Bear Lahai Roi Subdivision 2022 Addition KPB File 2022-089 Segesser Surveys / Smardo Nikiski Area

ITEM 6 - BEAR LAHAI ROI SUBDIVISION 2022 ADDITION

KPB File No.	2022-089
Plat Committee Meeting:	July 18, 2022
Applicant / Owner:	Jeffrey and Caroline Smardo of Kenai, AK
Surveyor:	John Segesser / Segesser Surveys
General Location:	Kenai Spur Highway, North Woods Street, Nikiski

STAFF REPORT

Vicinity Map

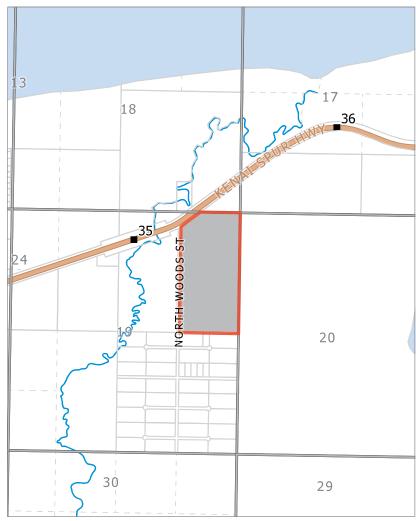
- **Staff recommendation:** The Kenai National Wildlife Refuge boundary should be depicted and a label added
- G. The status of adjacent lands within 100 feet of the proposed subdivision boundary or the land status across from any dedicated rights-of-way that adjoin the propose subdivision boundary, including names of subdivisions, lot lines, block numbers, lot numbers, rights-of-way; or an indication that the adjacent land is not subdivided:
